STAFF REPORT
COMMUNITY DEVELOPMENT DEPARTMENT

SUBJECT: H-2022-0030 – Overland & Wells II –
MDA, CUP, ALT

LOCATION: 2600 E. Overland Rd., in the SE ¼ of
Section 17, Township 3N., Range 1E.
(Parcel #S1117438626)

**ILLUSTRATIVE
LANDSCAPE PLAN**

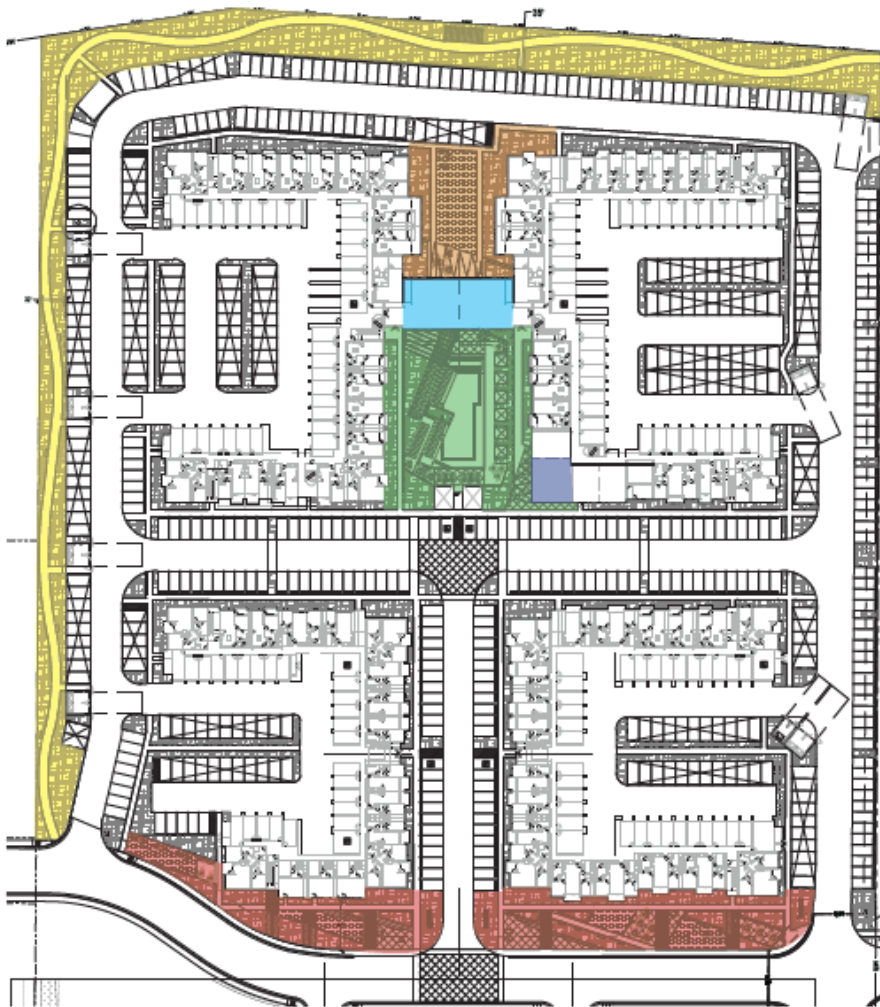
A total of 110,905 square feet (or 2.55 acres) of common open space is proposed consisting of linear open space along the north & west boundaries of the site with a 10-foot wide multi-use pathway connecting to the pathway in the first phase of the development to the east; a park with grass consisting of 9,803 s.f. in area; a large amenity area; roof-top terraces on the clubhouse and leasing office; and street buffer and additional common area along E. Cinema Dr., a local street as depicted on the open space exhibit in Section VIII.D.

There is an existing 40-foot wide sewer easement centered on the west property boundary (20' on this site) that contains an access road. A 14-foot wide access road is required to be maintained on this site; lawn and shrubs are allowed outside of the access road area within the easement but trees are not. Staff recommends an additional 5-feet is provided outside of the easement area for trees per the standards listed in UDC [11-3B-8C](#) and [11-3B-12C](#); or, apply for alternative compliance as set forth in UDC [11-5B-5](#). (Note: If wheel stops are not proposed to be provided within abutting parking spaces, an additional 2-feet is required to be added to the adjacent buffer to allow for vehicle overhang per UDC 11-3C-5B; the length of parking spaces may be reduced by 2-feet to 17-feet if 2-feet is added to the buffer width.) In order to count toward the open space requirement, the area must not be less than 400 s.f. in area and shall have a minimum length and width of 20-feet and be fully landscaped. The non-landscaped area where the maintenance road is located may not count toward the common open space requirement; therefore, the open space exhibit should be revised and additional open space should be provided to meet the minimum ~~3.18~~ 3.15 acres. Also an option would be to request alternative compliance to the common open space standards listed in UDC 11-4-3-27C per 11-4-3-27C.3b. Note: The allowance for alternative compliance (ALT) was intended to apply to the baseline common open space requirement but was inadvertently placed in the wrong code section with the last amendment – this is being rectified with the next series of code amendments but until then, ALT can be requested.
